**3-E-24-HZ**  
**APPLICATION FOR CERTIFICATE OF APPROPRIATENESS**

217 E. Scott Ave. 37917  
Old North Knoxville H

Original Print Date: 3/8/2024  
Knoxville/Knox County Planning -- Historic Zoning Commission

## Staff Findings

## Front Elevation

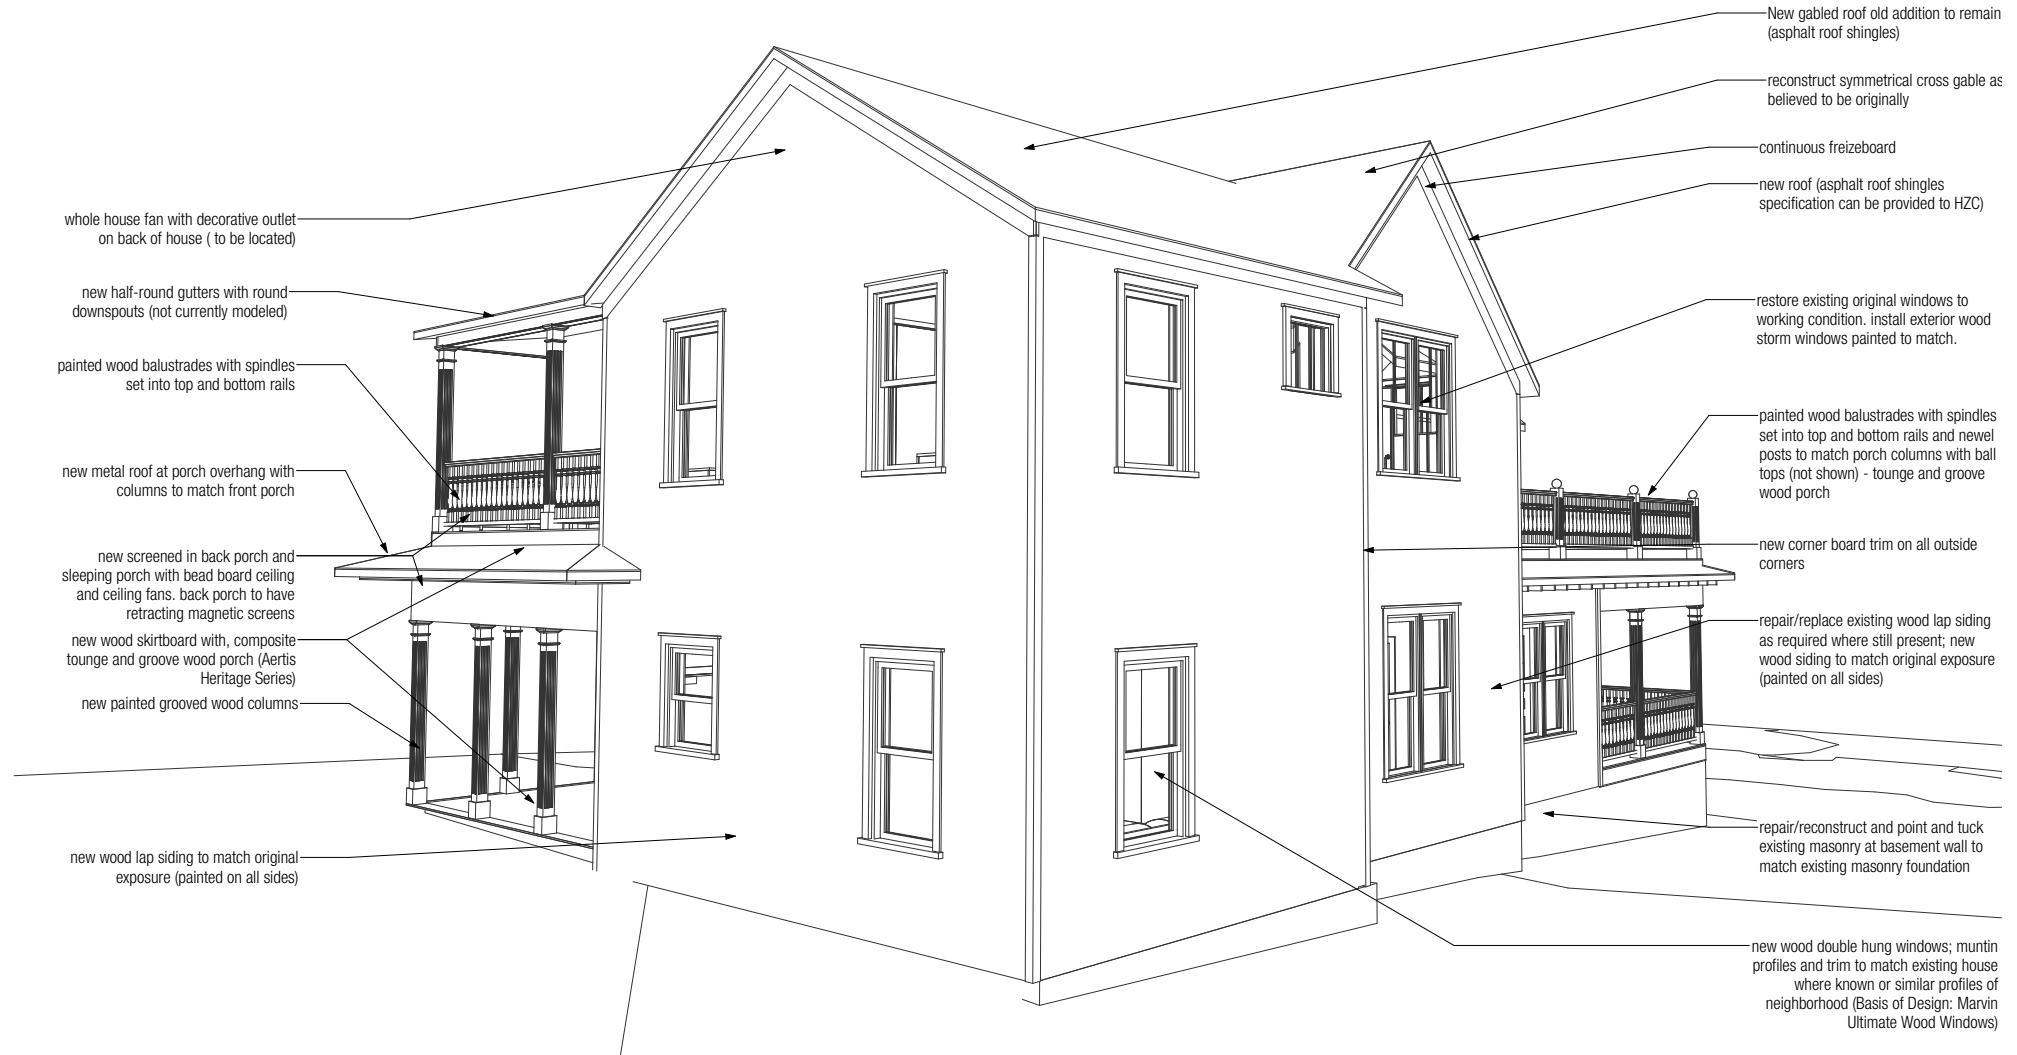
6. The proposed front porch reflects the footprint as visible on the Sanborn map, and meets the guidelines of "replicating the original porch if documentation of its size [...] can be discovered". Both stories of the porch incorporate design elements recommended within the guidelines (tongue-and-groove floors, balustrades with spindles set into top and bottom rails, wood columns). The proposed composite tongue-and-groove porch flooring material has been approved by the HZC as a replacement material in Old North Knoxville. The Commission should discuss the second-story porch element; there is no historic evidence of a second-story porch on the house, and the level of decoration/detail on the proposed porches.

The Commission should discuss the proposed second-story porch, the level of detail for the porch columns and balustrade, and the proposed shingles on the front gable.

Pending approval of, or any additional conditions related to those elements, staff recommends approval of Certificate 3-E-24-HZ, subject to the following conditions: 1) final window selections to be provided to staff for approval; 2) final site plan, including ADU and new driveway, should meet the City Zoning Code and City Engineering standards; minor revisions may be approved by staff.

## GARAGE ADU ELEVATIONS

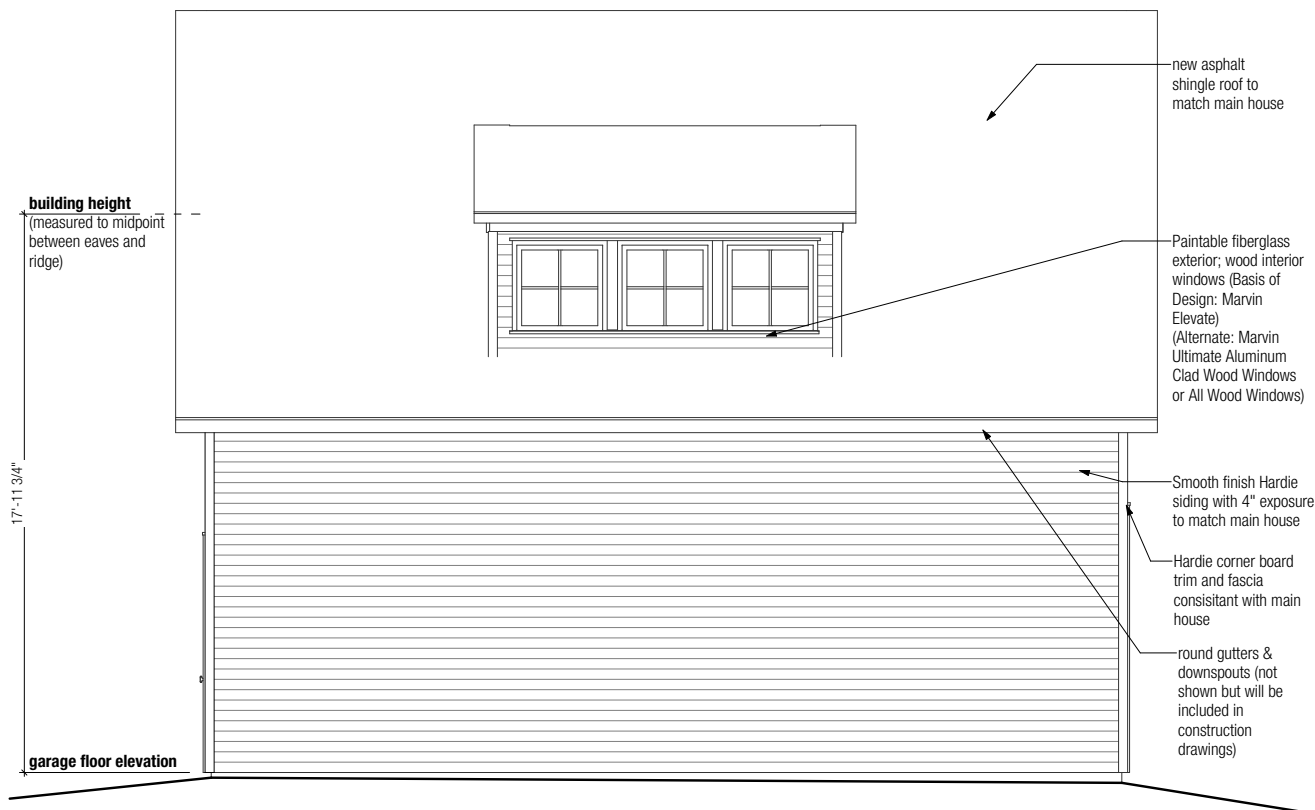
11. The secondary structure/garage and ADU meets the design guidelines for new accessory structures. Placement of the building at the rear of the property, minimally visible from the right-of-way, is appropriate. Final site plan for the ADU, and any related driveway, should meet the City zoning and Engineering standards.

12. The secondary structure is compatible in design with the primary house. Smooth-finished fiber cement lap siding and painted fiberglass windows have been approved for new secondary structures in ONK. The proposed solar panels are on a less visible roof slope.
